A Performance Assessment Methodology for Low-Level Radioactive Waste Disposal Facilities

Recommendations of NRC's Performance
Assessment Working Group

Manuscript Completed: October 2000
Date Published: October 2000

Figure 3. Section 3.1: Detail to the "Example of an Acceptable Process for Demonstrating Compliance with 10 CFR 61.41." The activities shown by the dotted lines depict the compliance review the NRC staff is expected to perform.

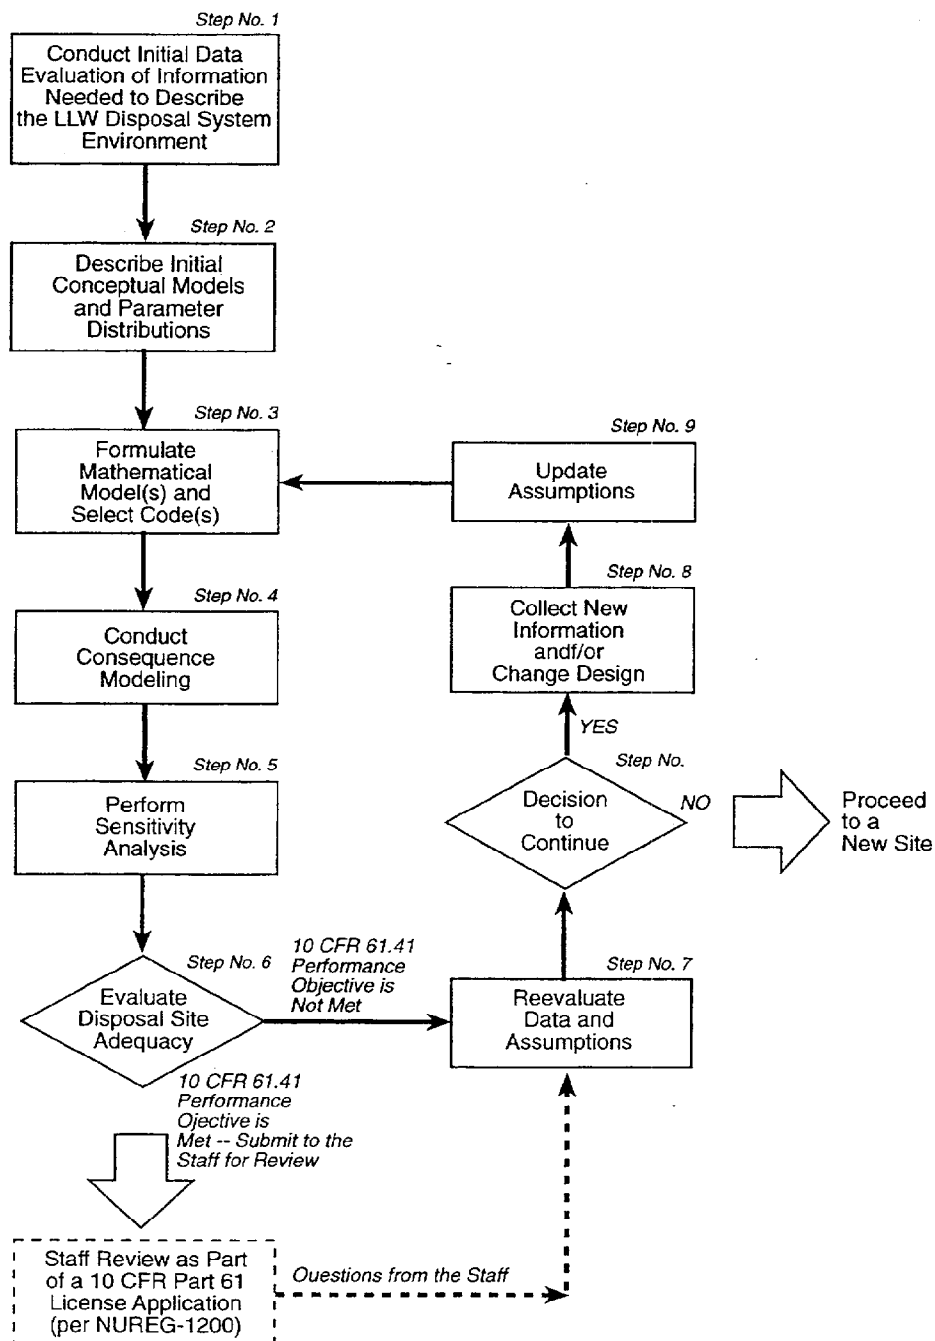
11. Page 3-2; "Branch Technical Positions (With Discussion)," Figure 3. Where does the option of limiting radionuclide inventory fit into this flow chart? Limits on radionuclide inventory may change a disposal site's rating from "inadequate" to "satisfactory."

7. Page 1-15, Paragraph 3. We strongly concur, and hope that the regulators are able to participate in such a process without compromising their objectivity. This might be indicated on Figure 3 [Technical Position 3.1: Detail to the "Example of an Acceptable process for Demonstrating Compliance with 10 CFR 61.41"], if appropriate.

In practice, the PAWG believes that the approach outlined in Section 3.1 of this technical report (and depicted in Figure 3) should result in a supportable demonstration of compliance with 10 CFR 61.41. *Step No. 6* of the process is the logical ending point for the required assessment; specifically, having

As noted in the response to *Golder Associates' General Comment No. 6*, the PAWG believes one of the tenants of good and effective regulation is to interact early and frequently with potential licensees. With this philosophy in mind, the NRC staff (or any other State regulatory authority) would, at the request of potential licensees, interact on any or all of the LLW performance assessment process steps described in Figure 3.

Figure 12. Conceptualization showing potential surface water contamination pathways. (All radionuclides distributed in the aquifer, in the vicinity of the surface-water body, are discharged into it.)

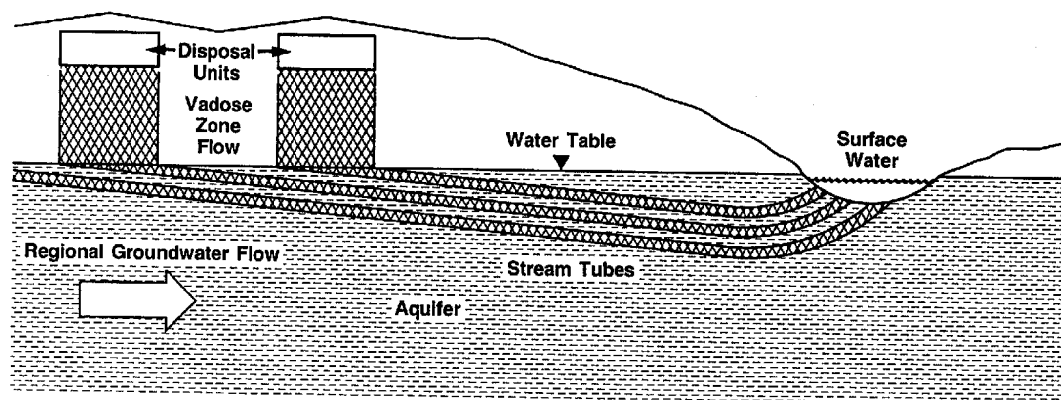
5. Section 3.3.6.2.1, "Surface Water. Considerations" (p. 3-61): The first sentence of this section references Figure 13. Figure 12 appears to be the more appropriate reference.

Figure 14. Example of potential dose pathways to be considered in an LLW performance assessment. [Determination of appropriate pathways depends on site-specific information (i.e., habits of the critical group). Adapted from EPA (1972).

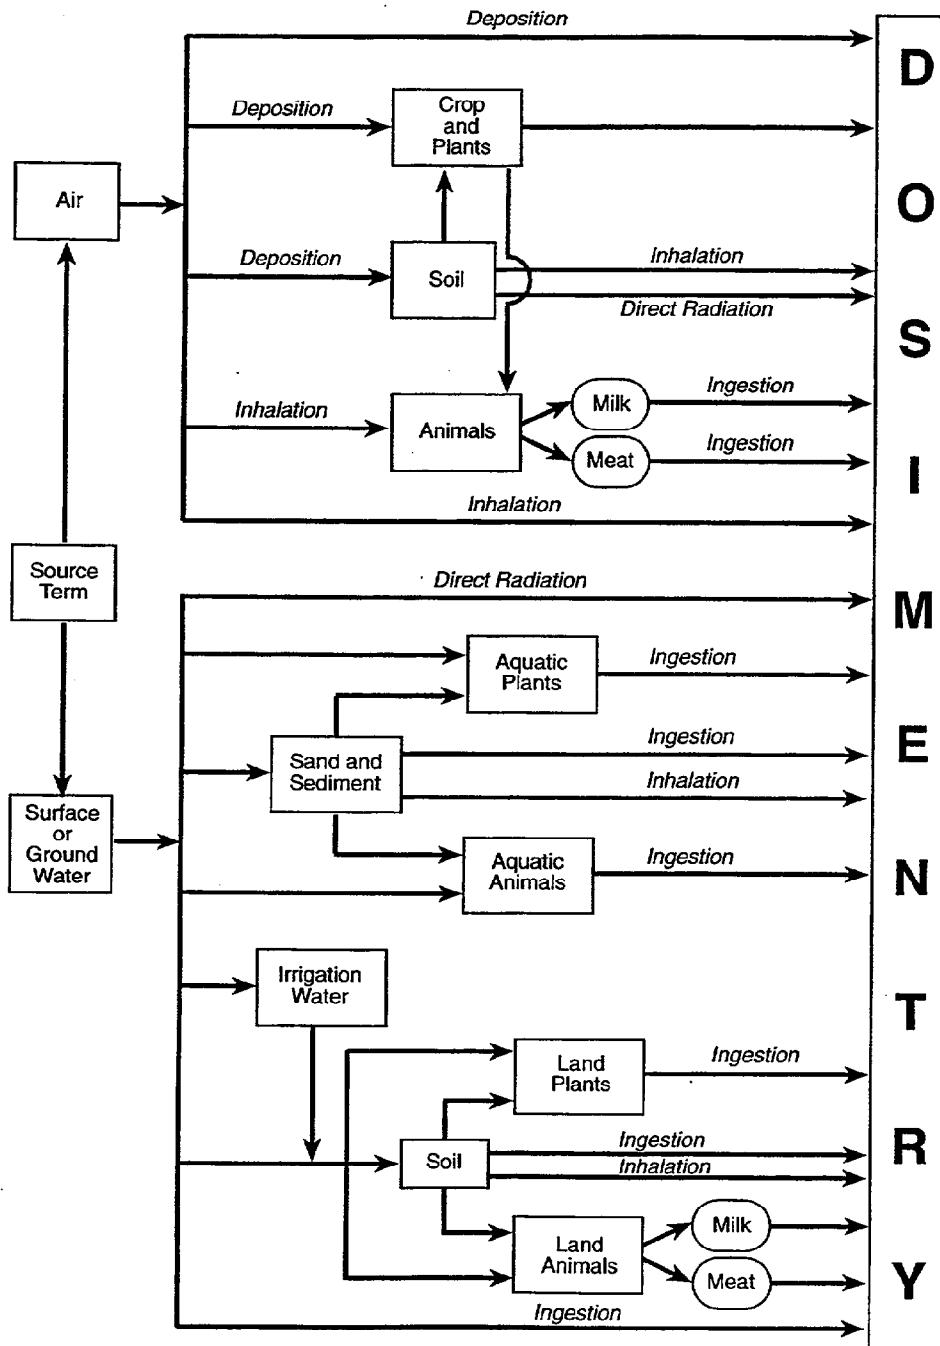
2. Page 3.75, Figure 14, this figure contains an unusual label [sic] "Fishing and Sports Gear." If this level of specificity was used uniformly throughout the diagram it may become too cluttered to be useful.

7. On Figure 14, the mechanism by which exposure is received by the individual (i.e., ingestion, inhalation, direct radiation) is identified in italics for some but not all of the pathways depicted. Specifically, the milk and meat pathways at the bottom of the figure should specify "ingestion," and the fishing and sports gear category and sand and sediments category should specify "direct radiation" if that is the intent.

The PAWG agrees with this comment. Figure 14 has been revised accordingly.

Figure 14 has been revised based on these comments.

Figure B-2. PAWG-recommended approach to calculating the peak of the mean dose.

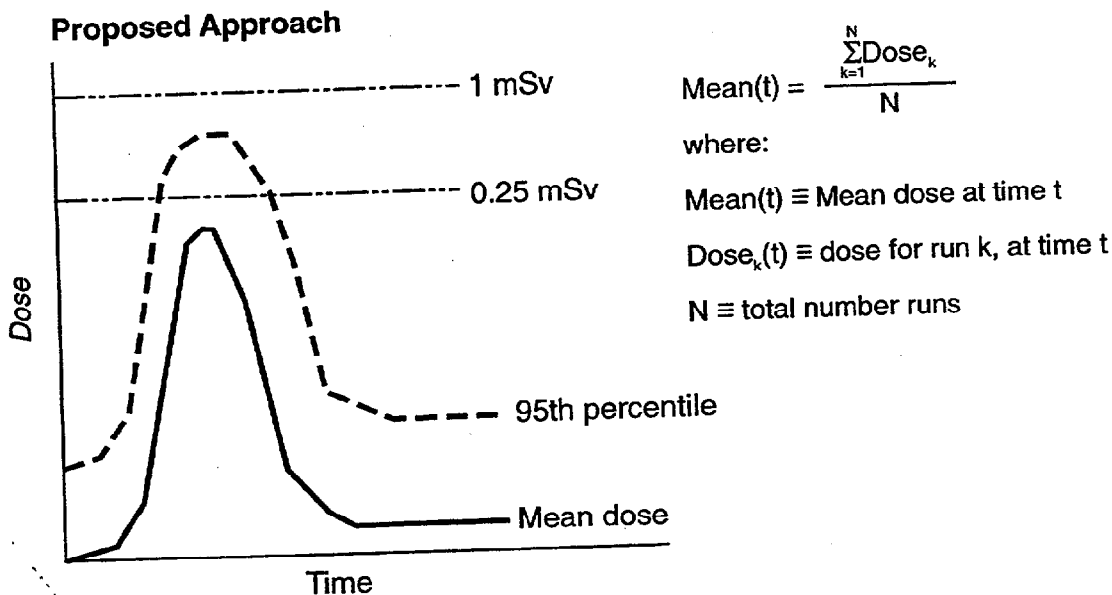
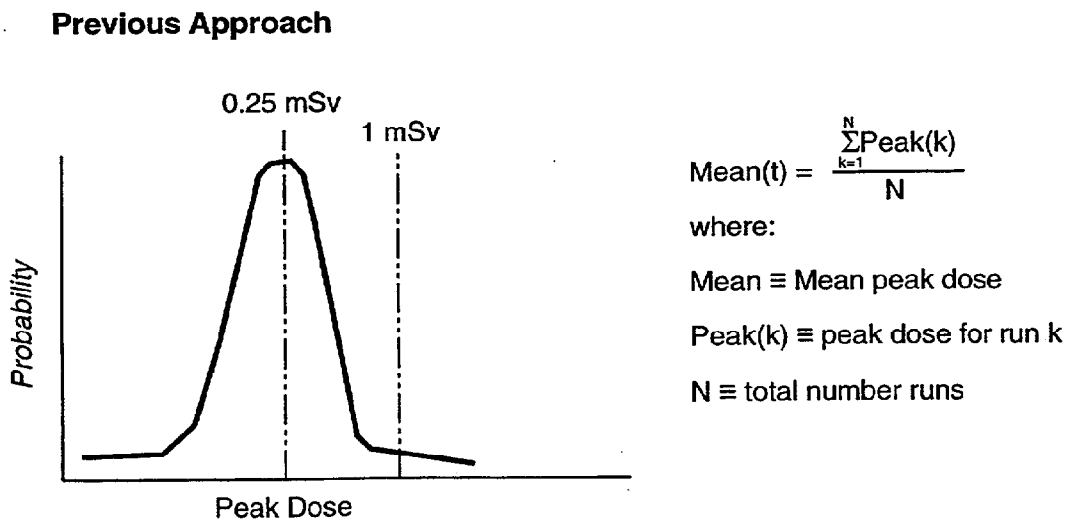
disposal system and is the most direct measure of risk. See Figure B-2. Further, placing a limit on the upper 95th percent confidence of the dose distribution provides additional assurance of the acceptable performance of the site – constraining the 95th percentile of the distribution to 1.0 milliSievert (mSv) [100 millirem (mrem)], as shown in Figure B-2. [In response to this and other comments, the PAWG staff have modified Paragraph No. 2 of Section 3.3.2.3.2 of this technical report (“Probabilistic Analysis”) to describe how the mean dose as a function of time can be derived mathematically, consistent with Item (a), shown in Figure B-2.]
